STERLING RANCH ROAD & BRIARGATE PARKWAY STORM PLANS

STORM SEWER PLANS

PCF FILING NO.: CDR 221

v4_CDs Storm.pdf Markup Summary

DP16 PROFILE
STA 10+00.00 TO 10+91.02
PUBLIC

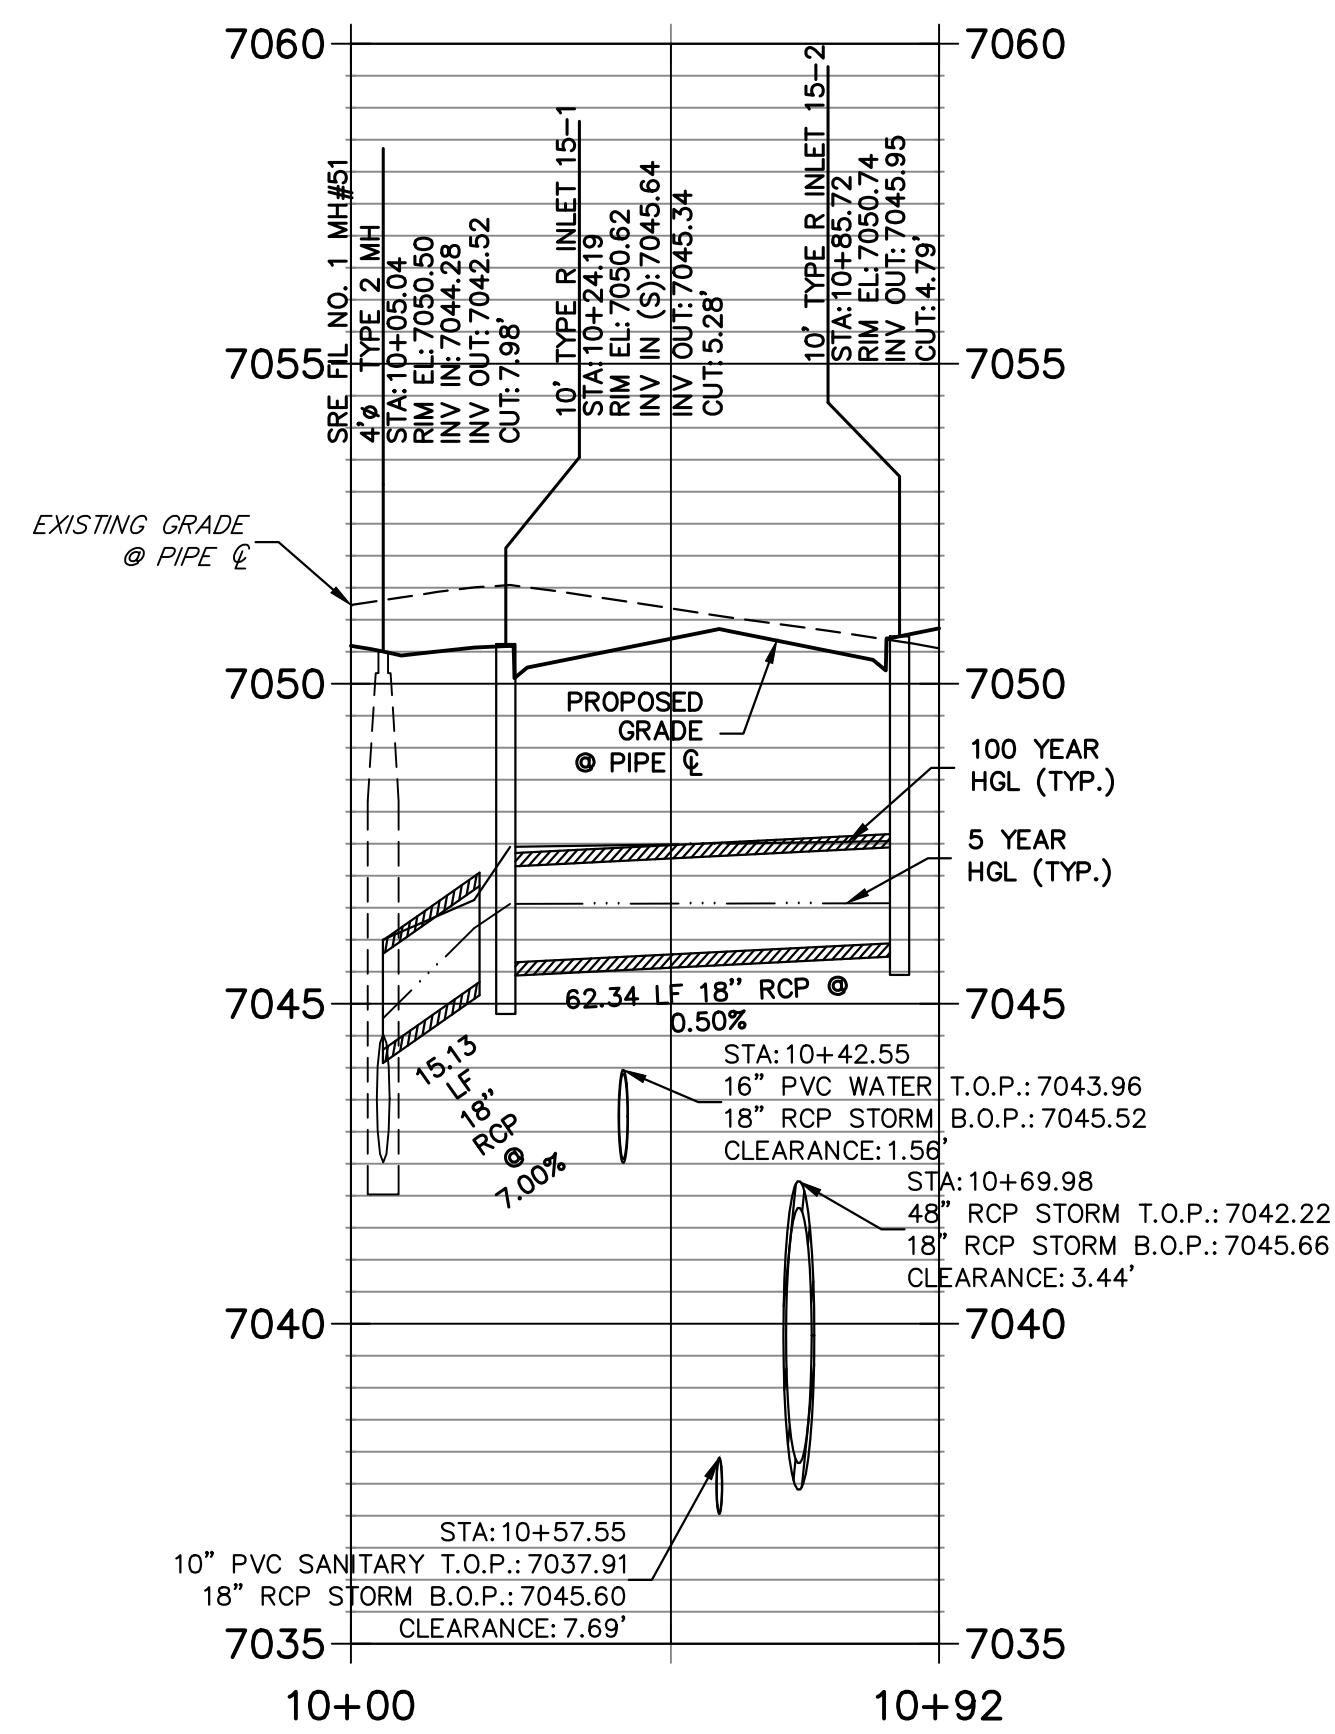
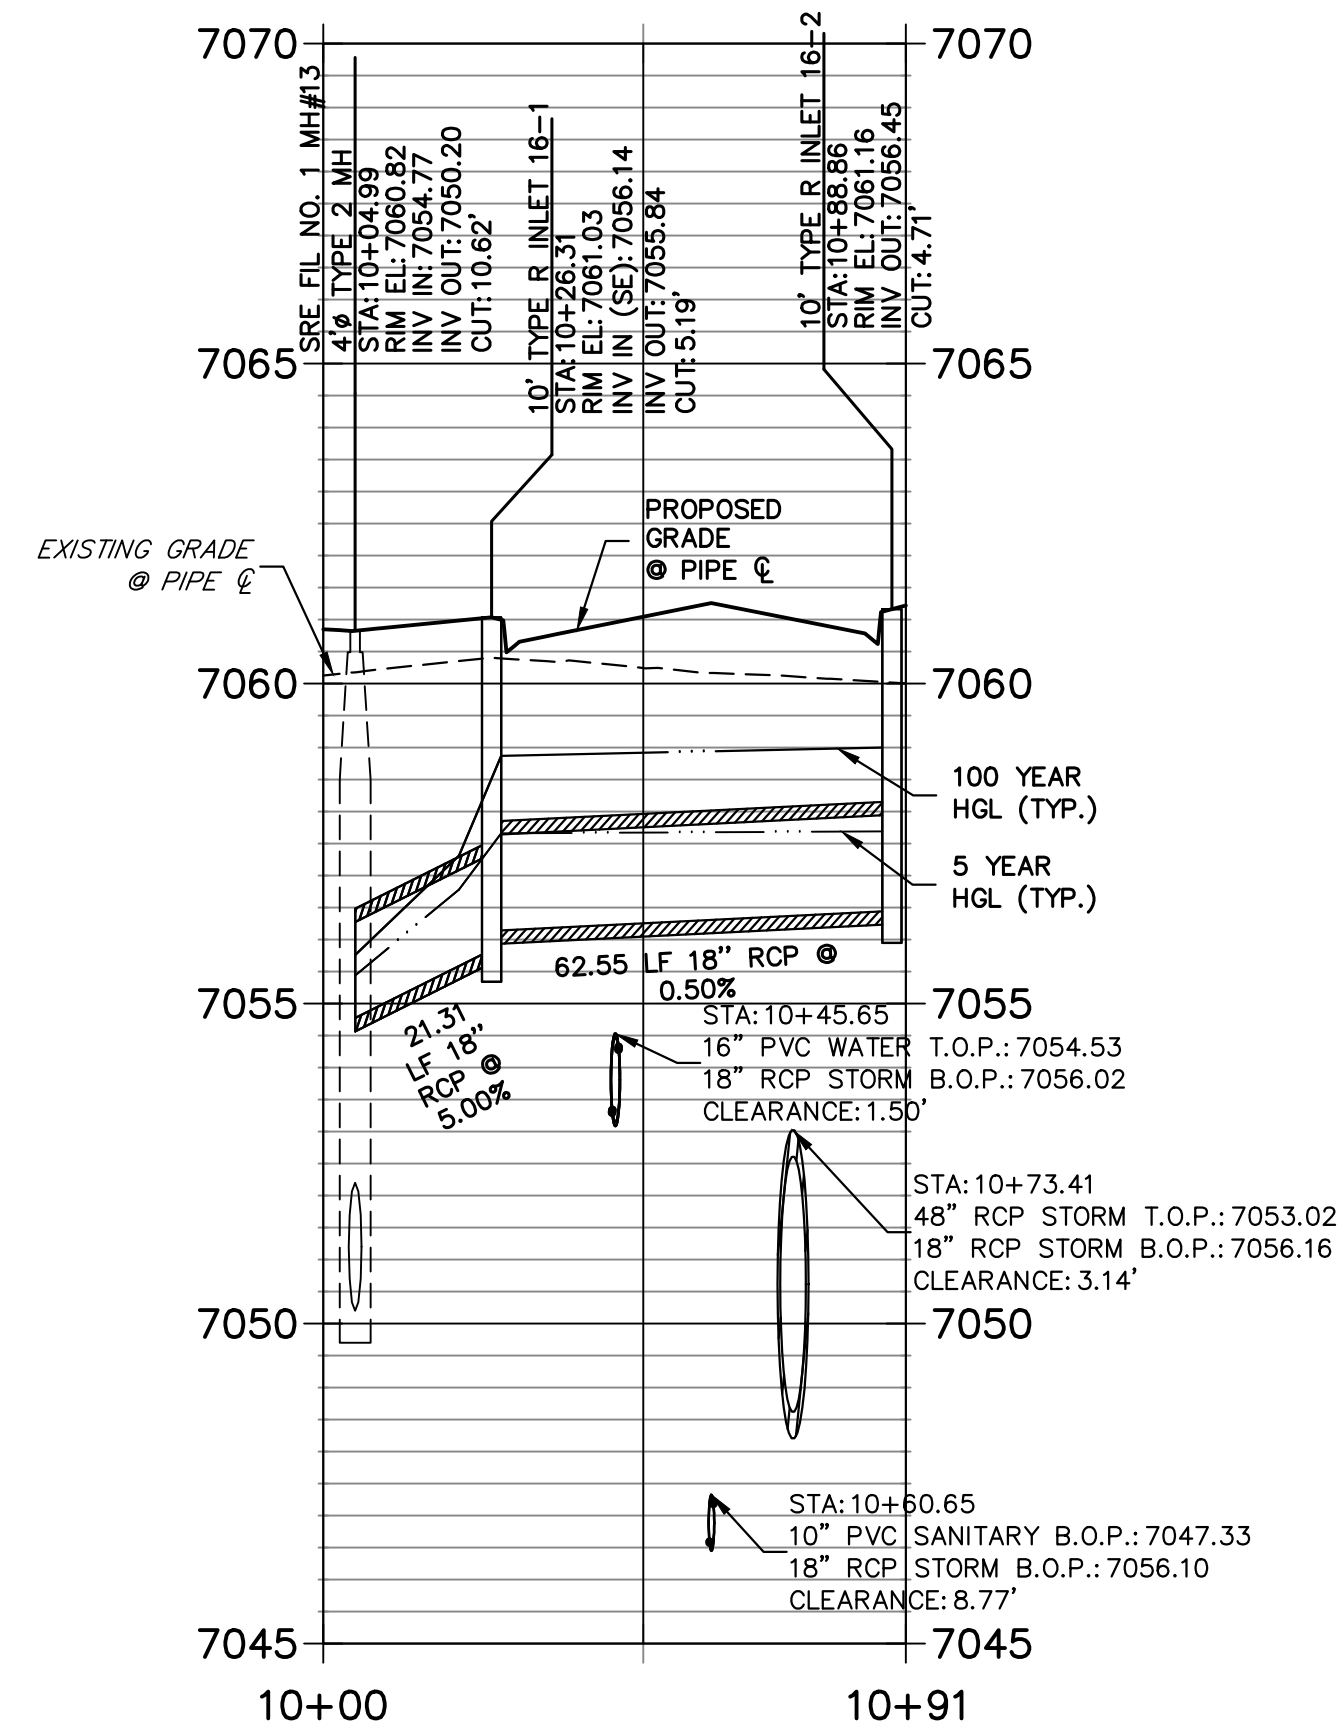
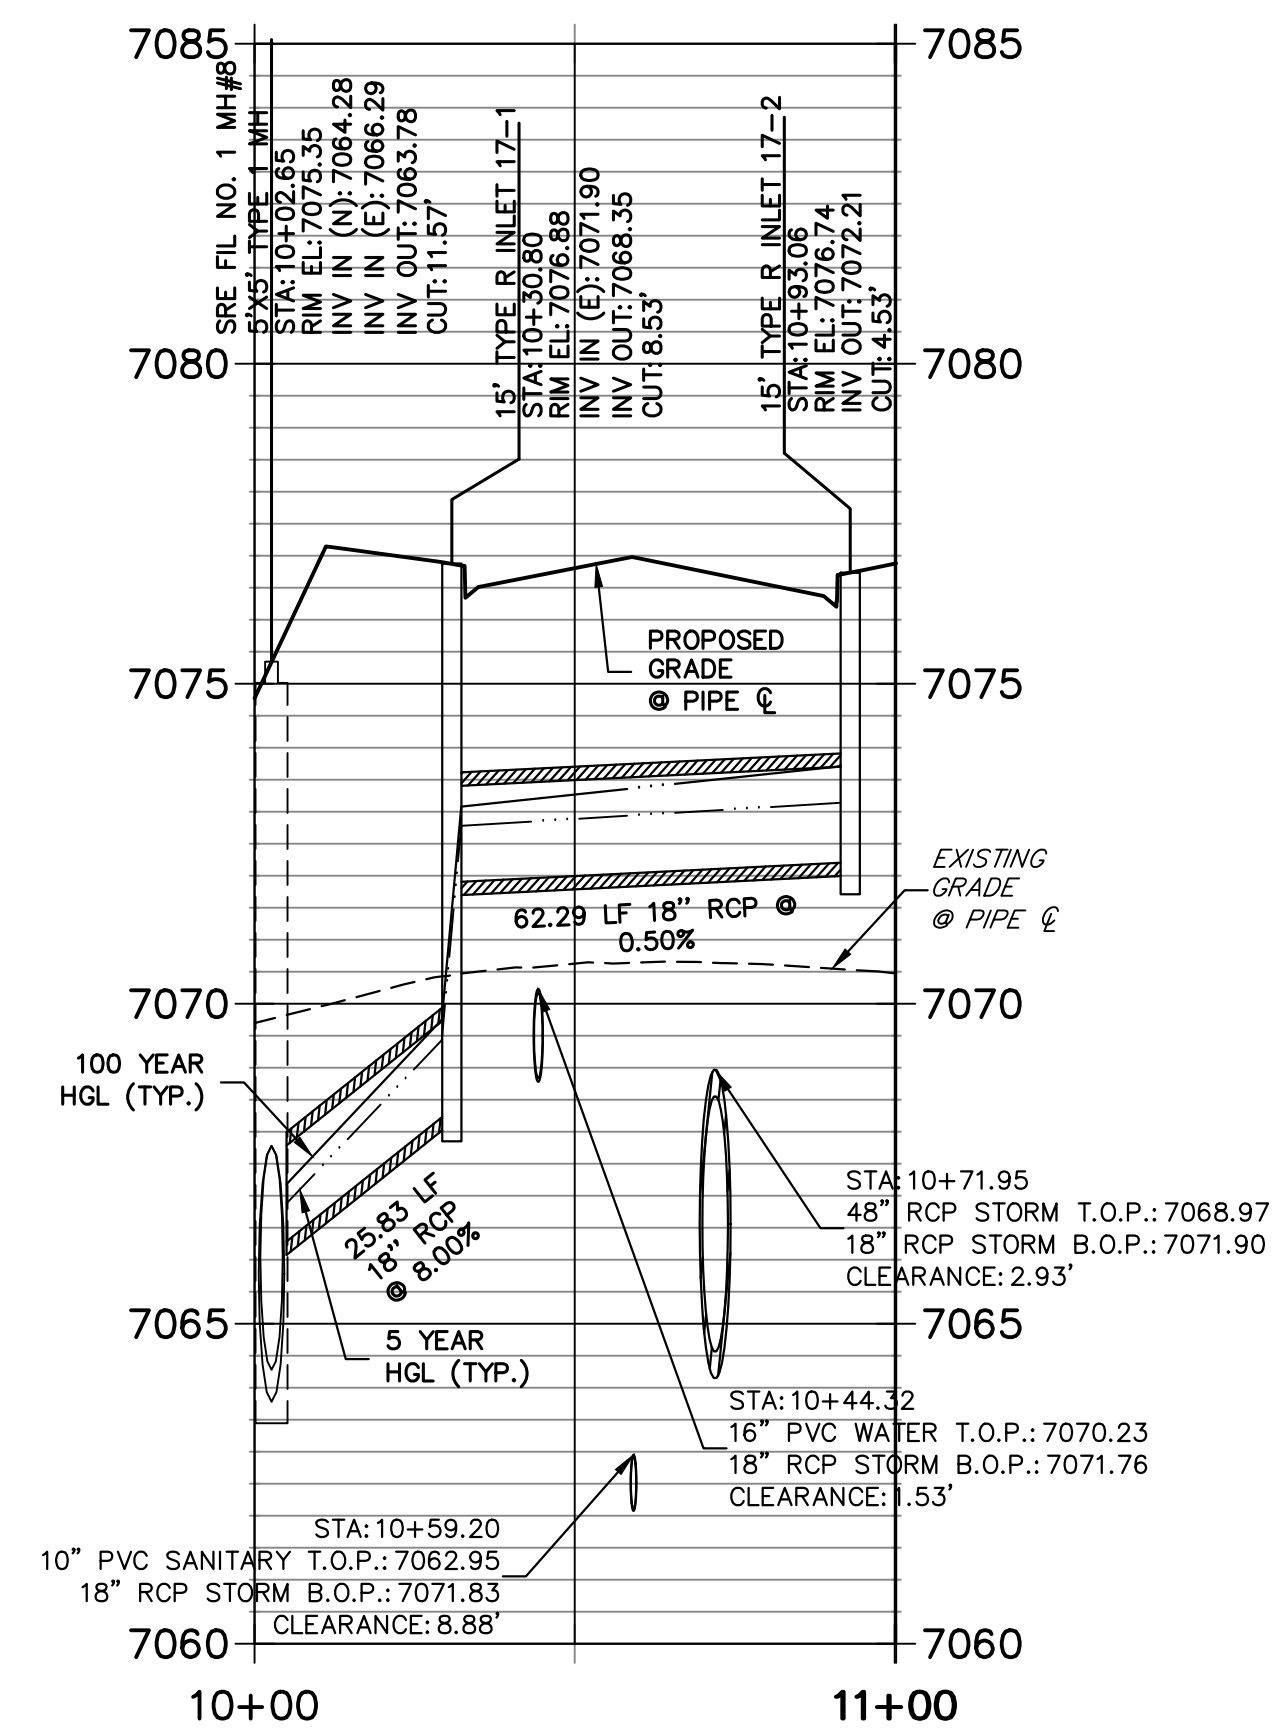
Missing Ex. Inv Out label

Label existing storm and reference project/plan set design is in.

This pipe should also be class 4, as it's located within Briargate Pkwy
